**PLANNED UNIT DEVELOPMENT
& SUBDIVISION STAFF REPORT****Date: June 3, 2010****DEVELOPMENT NAME**

Oakleigh Place Subdivision

2709 Hillcrest Road

Planned Unit Development Approval to allow reduced side yard setbacks and increased site coverage in an R-1, Single-Family Residential District, and Subdivision approval to create 19 lots.

SITE PLAN

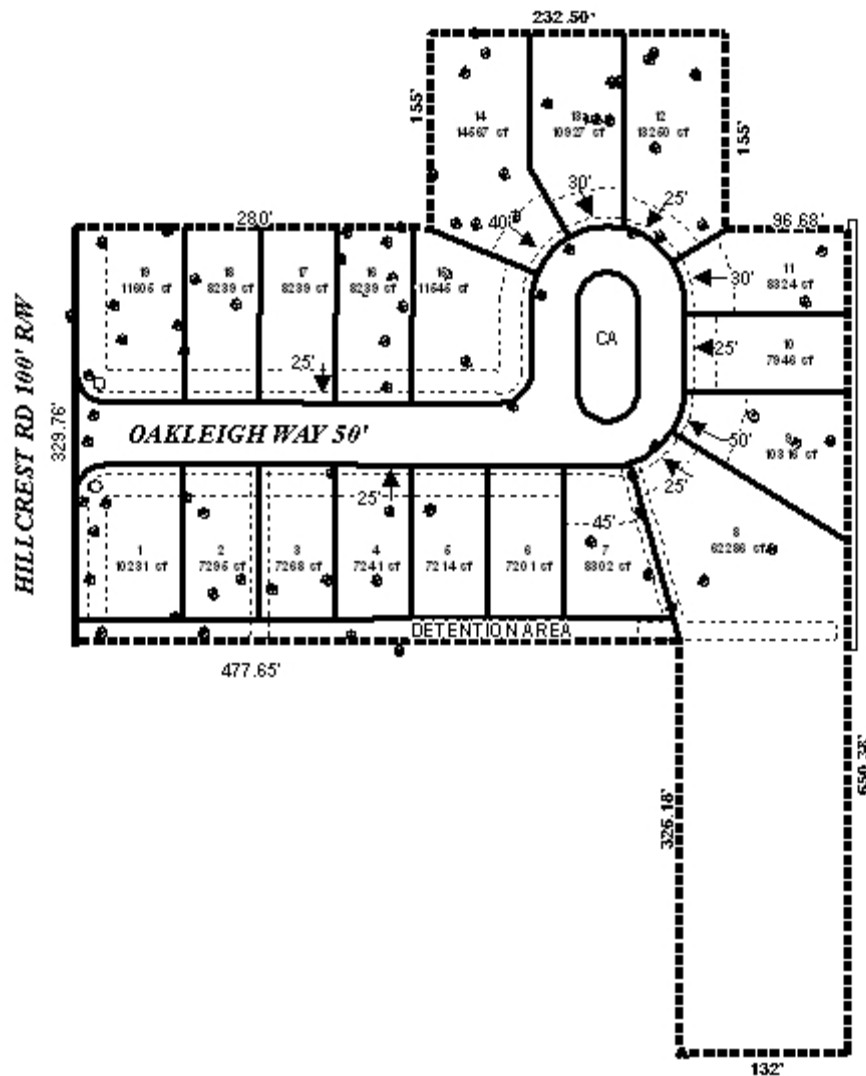
All 19 proposed lots appear to meet minimum size requirements, and each are labeled with their size in square feet on the preliminary plat. All lots also have the minimum front setback lines depicted and labeled, including the corner lots that have a secondary frontage onto Hillcrest Road. It should be noted that some of the front setbacks exceed the 25-foot minimum, as they are placed where the lot is 60-feet wide. These items should be retained for the final plat and site plan, if approved.

Proposed Lot 8 exceeds the width to depth ratio of Section V.D.3. of the Subdivision Regulations, however, the shape of the property makes it difficult to provide adequate street frontage. A waiver of this section may be appropriate.

It appears that a privacy / entrance wall has been built along the Hillcrest Road frontage for the development. Staff can find no evidence of building permits for the wall, and the wall is not indicated on the PUD site plan for this application or any previously approved application. The PUD site plan and the Subdivision plat should be revised to depict the wall as constructed, including the height, and permits should be obtained after the fact. If the wall is located in the right-of-way, separate approvals and permits will also be required.

- 1) Revision of the plat to depict and label (including height) the privacy / entrance wall that has been constructed along the Hillcrest Road frontage of the development, and the obtaining of building permits after the fact for the wall;

- 2) Depiction and labeling of the minimum building setback line to be at least 25-feet from all street frontages for all lots, or where the lot is a minimum of 60 feet in width for lots less than 60-feet wide at the street, as shown;

- 3) Placement of a note on the site plan and plat stating that the maximum building site coverage per lot is 40%, the minimum side yard setback is 5 feet, and the minimum rear yard setback is 8 feet, as shown;
